City of Phoenix
PLANNING AND DEVELOPMENT DEPARTMENT

Staff Report: Z-41-21-7
September 10, 2021

Laveen Village Planning Committee Meeting Date September 13, 2021
Planning Commission Hearing Date October 7, 2021
Request From: [S-1](#) (Approved [C-2/CP-GCP](#)) (14.56 acres)
Request To: [C-2](#) HGT/WVR DNS/WVR (14.56 acres)
Proposed Use Multifamily residential with a height and density waiver
Location Approximately 615 feet north of the northwest corner of 59th Avenue and Dobbins Road
Owner The Williams Family Living 1996 Trust
Applicant Anne Healy, P.B. Bell
Representative Manjula M. Vaz, Gammage & Burnham, PLC
Staff Recommendation Approval, subject to stipulations

Proposed Site Plan
Source: BMA Architecture

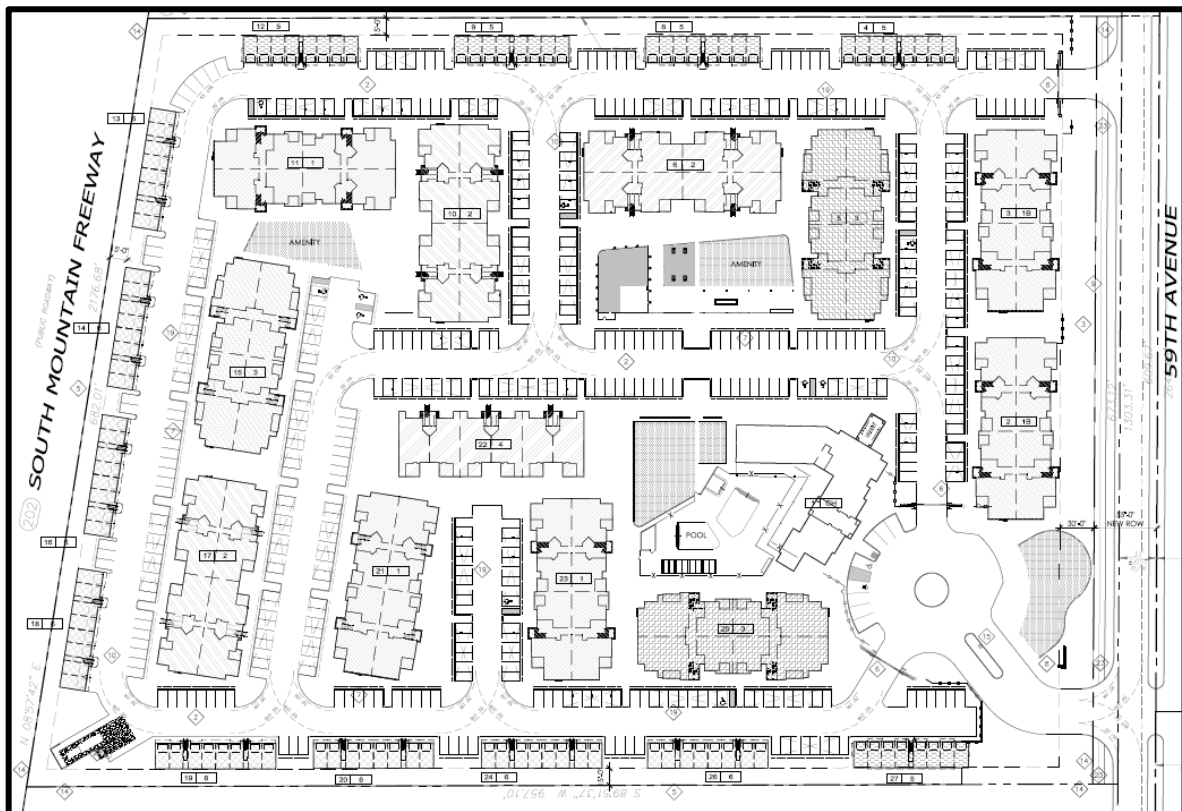
5. The proposed site plan depicts a multifamily residential development consisting of a mix of building types ranging from one to three stories in height, and residences ranging from one to three bedrooms units. The development proposes two vehicular entry drives along its 59th Avenue frontage. The southernmost driveway contains a roundabout style driveway entry that connects to two separate gated vehicular entries into the development. This driveway area will also have guest parking spaces with pedestrian access to the leasing office and clubhouse. The site plan depicts several desirable site design elements and amenities, which are further reinforced through staff recommended stipulations (discussed below). As such, staff is recommending general conformance to this site plan, per Stipulation No. 1.

Proposed Site Plan
Source: BMA Architecture

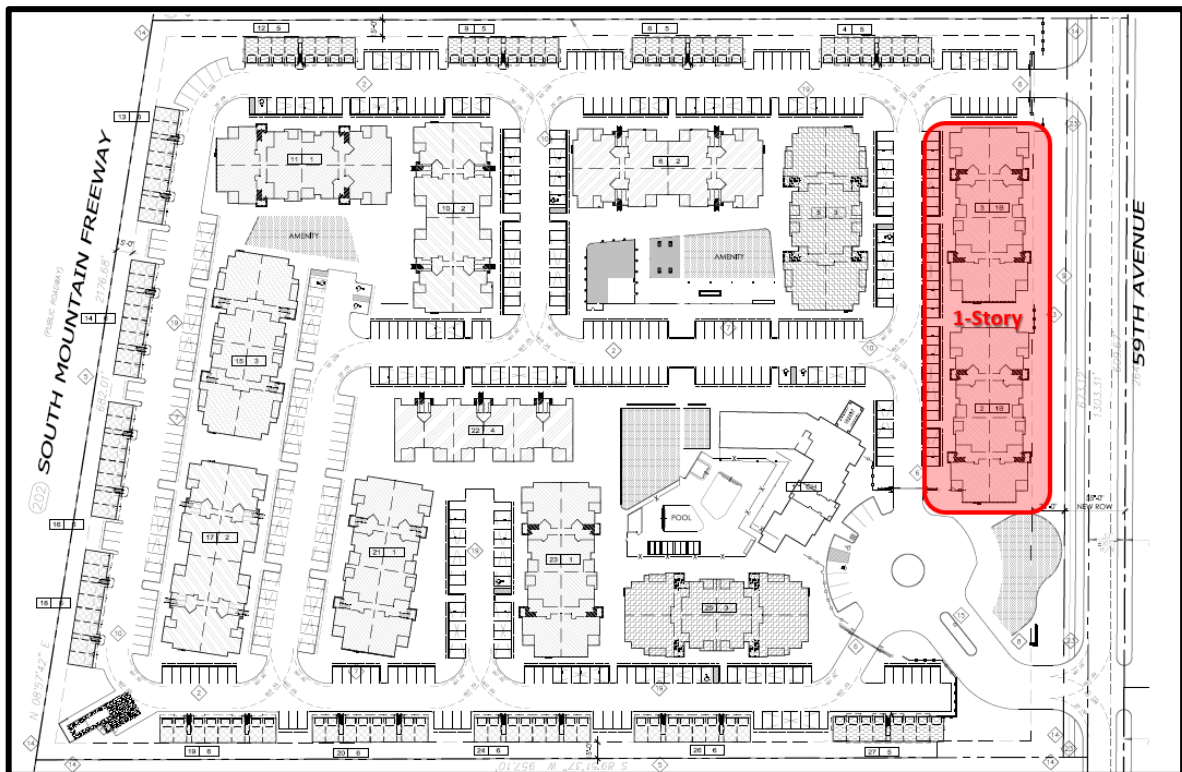
As noted in Background Item No. 3, the property to the east of the site, across 59th Avenue, consists of a single-family residential neighborhood with mostly single-story residences. To ensure an appropriate height transition as one moves west towards the Loop 202 freeway, staff is recommending that the buildings adjacent to 59th Avenue be restricted to a maximum building height of 2 stories and 30 feet, and all other buildings to a maximum of 3 stories and 40 feet. This is depicted on the proposed site plan and is addressed in Stipulation No. 2.

To further ensure an appropriate transition from the single-family residential community to the west, staff is recommending that a minimum 30-foot-wide landscape setback be provided along 59th Avenue. Within the streetscape setback, staff is recommending that large caliper trees be planted to provide both shade for pedestrians and a vegetative buffer between this site and the homes across the street. This is addressed in Stipulation No. 4. The site is also located along a planned trail as depicted in the city's Parks and Trails Map. This will be provided via a 10-foot-wide public Shared Use Path (SUP) along 59th Avenue and will be detached. Staff is recommending that the landscape strip between the SUP and back of curb be planted with minimum two-inch caliper trees, vegetation to prevent

mid-block crossings, and that a minimum of 75 percent shade be provided along the path at maturity. These recommendations are addressed in Stipulation No. 3.
